## AIRWORTHINESS DIRECTIVE

### Piper PA-34 (Seneca) Series Aeroplanes

**AD/PA-34/43  
Amdt 2**

**Nose Gear Upper Drag Link Bolt**

**Figure 1**

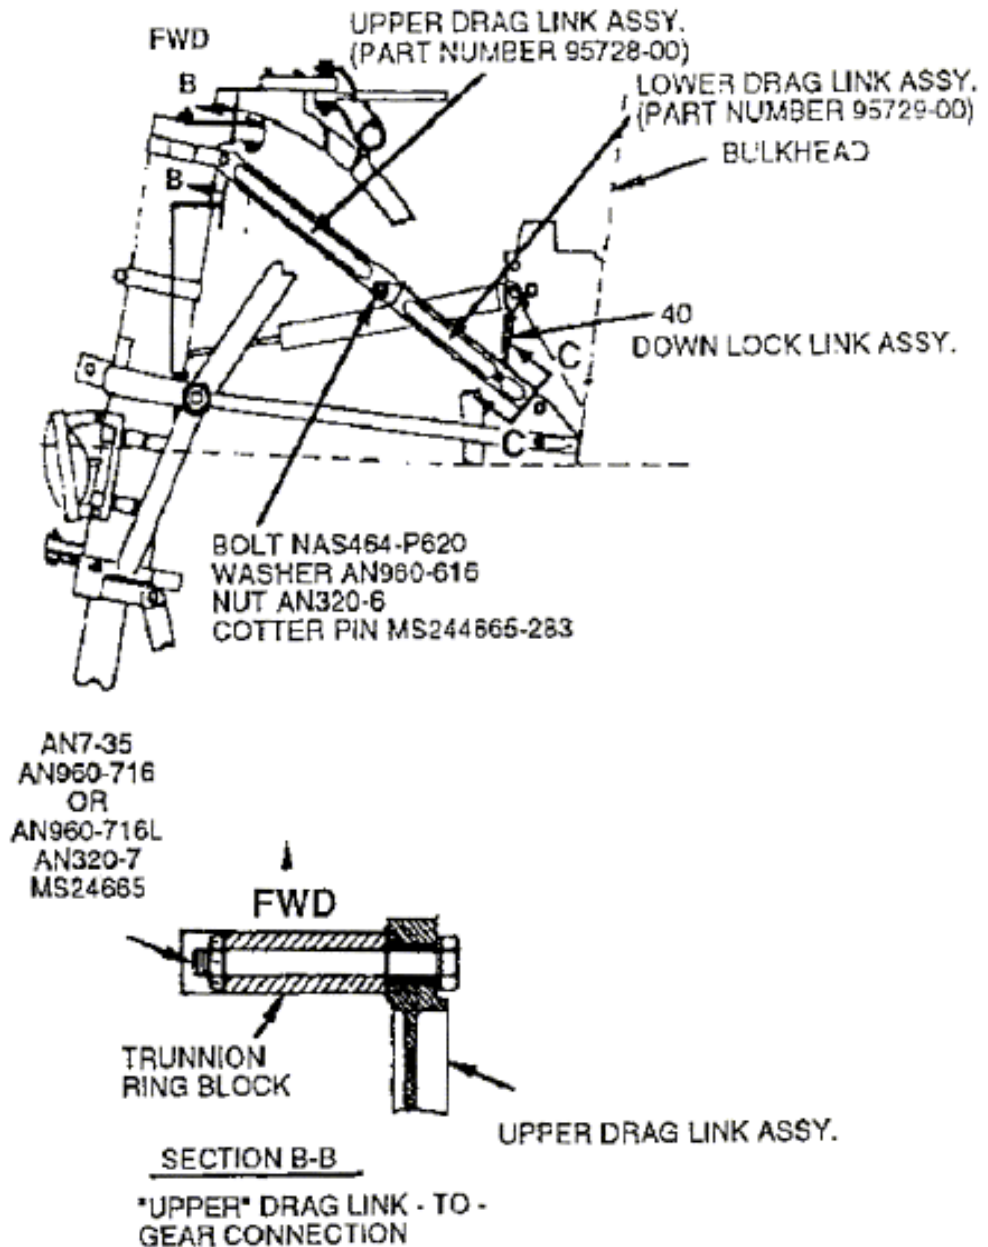
- Requirement:
1. Replace the bolt and attached parts that connect the upper drag link to the nose gear trunnion with the following new parts in accordance with Figure 1 of this Directive:
    - (a) Piper part number 400 274 (AN7-35) bolt.
    - (b) Piper part number 407 591 (AN960-716L) washer, as applicable.
    - (c) Piper part number 407 568 (AN960-716) washer, as applicable.
    - (d) Piper part number 404 396 (AN320-7) nut; and
    - (e) Piper part number 424 085 (MS24665) cotter pin.
  2. Carry out the inspections, replacements and other corrective actions specified in Table 1 "Scheduled Maintenance" of Piper Service Bulletin (SB) No. 1123B dated 20 April 2006 or later FAA approved revision.
  3. Do any necessary corrective actions as a result of the actions specified in Table 1 "Scheduled Maintenance" of Piper Service Bulletin No. 1123B or later FAA approved revision.
